UNITED STATES OF AMERICA
NUCLEAR REGULATORY COMMISSION

(Diablo Canyon Nuclear Power)
Plant, Units 1 and 2))

AFFIDAVIT OF DONALD R. GESKE

SUBJECT Comments on Proposed DR of ESD 241 UT Inspection
of Safety Valve Yoke Rods

SER 7862

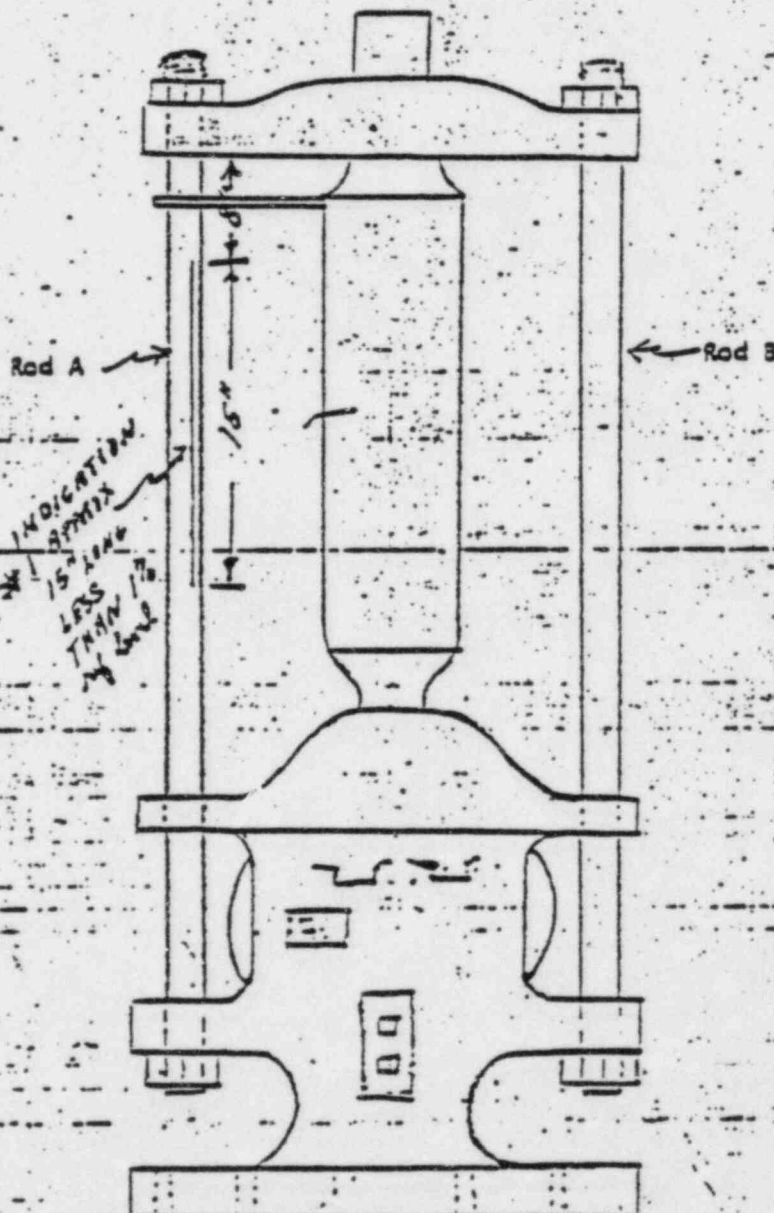
5. RESULTS OF EXAMINATION:
NOTE: USE DETAIL DRAWING OR SKETCH IF REQUIRED TO INDICATE LOCATION OF DEFECTS.
ONE LONGITUDINAL INDICATION LESS THAN 1% OF REFERENCE LEVEL.
THIS REPORT COVERS SERIAL NO 7862 ONLY

AS SHOWN ROD "A" ON VALVE SERIAL NO. 7862 HAS
AN INDICATION WHICH DOES NOT EXCEED
THE REJECTABLE LEVEL. BASED ON THESE
REPORTS THE FIELD WOULD LIKE TO ACCEPT THESE
RESULTS & DELETE THE REQUIREMENT FOR A DYE
PENETRANT EXAMINATION OF THE THREADED
AREA OF THE RODS.

The yoke rods look satisfactory in light
of the UT inspection. The indication on Rod "A"
on Valve No. 7862 is reported as a surface
seam. This type of defect should not
interfere with the safe operation of the
Safety Valve. I have attached the Engineering
release to this memo for your review.
